| Project | IEEE 802.16 Broadband Wireless Access Working Group < http://ieee802.org/16 > | |
| Title | UL ACK Channel Enhancement | |
| Date Submitted | 2004-07-08 | |
| Purpose | Adopting of proposed method into P802.16e | |

Figure bb1—Subcarrier Mapping of UL ACK Modulation Symbols for PUSC

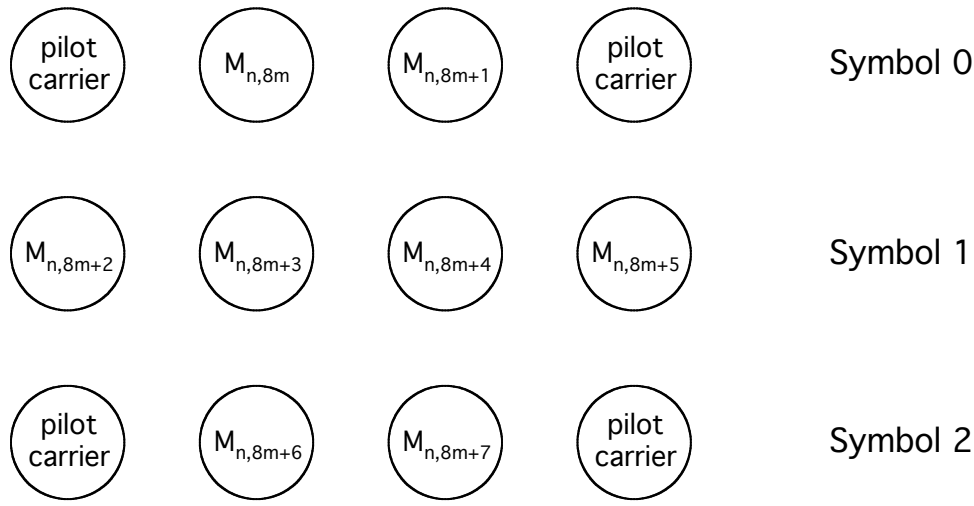
$M_{n,8m+k}$ is mapped to UL ACK channel tile as shown in Figure bb1 for PUSC uplink subchannel and in Figure bb2 for optional PUSC uplink subchannel. An UL ACK channel is mapped to half subchannel composed of 3 tiles.

Figure cc—UL ACK channel link performance

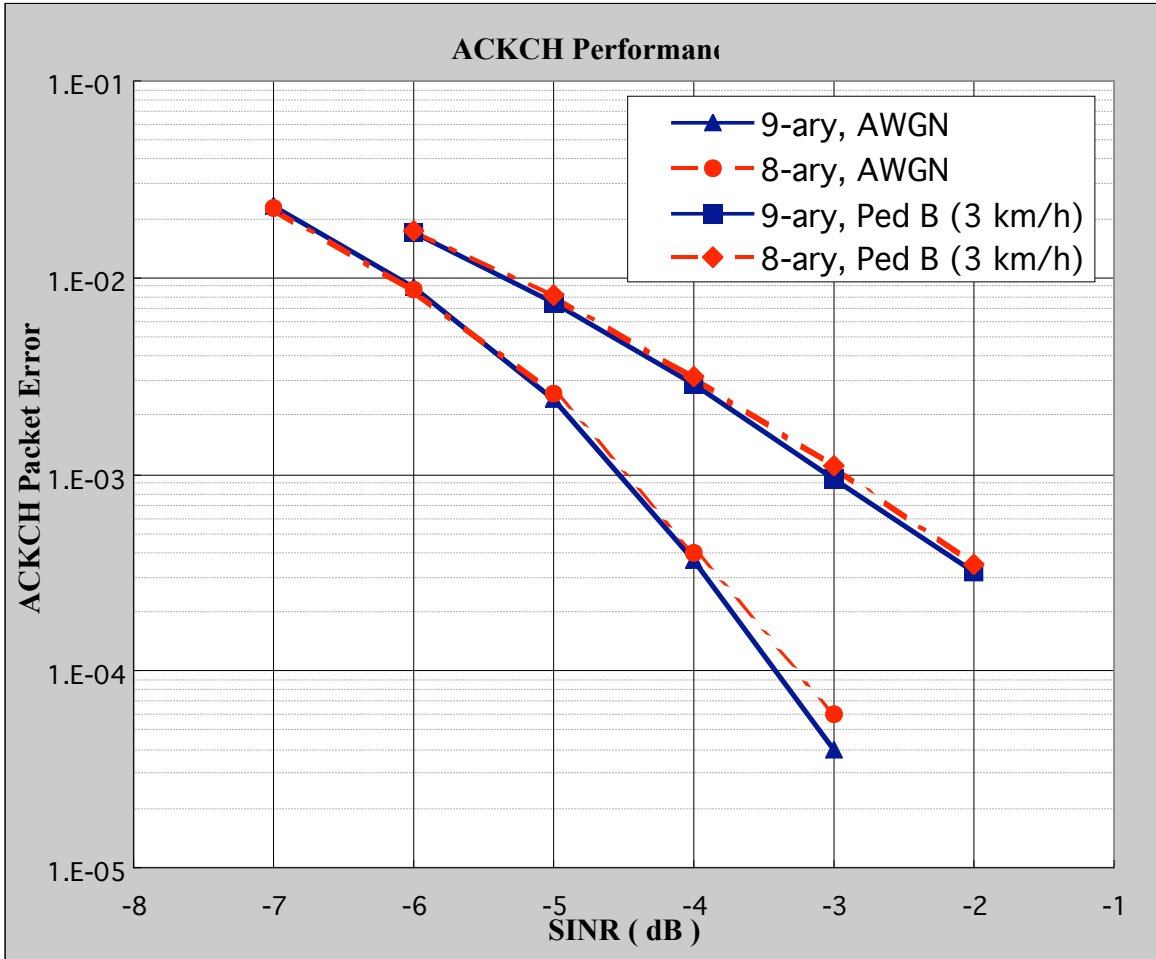
Simulation results of UL ACK channel link performance are shown in Figure cc. In the simulations, AWGN and Ped-B (3km/h) channels with 2 receive antennas are considered. Figure cc shows UL ACK error rate versus SINR (Signal to Interference and Noise Ratio per subcarrier) with 9-ary and 8-ary schemes. 9-ary denotes the current scheme in 802.16d D5, whereas 8-ary denotes the proposed scheme in this contribution. We can see that in most region, the proposed scheme and the current scheme have almost the same performance. Therefore the proposed scheme can become fit for both uplink subchannel and easy implementation at no cost of performance.
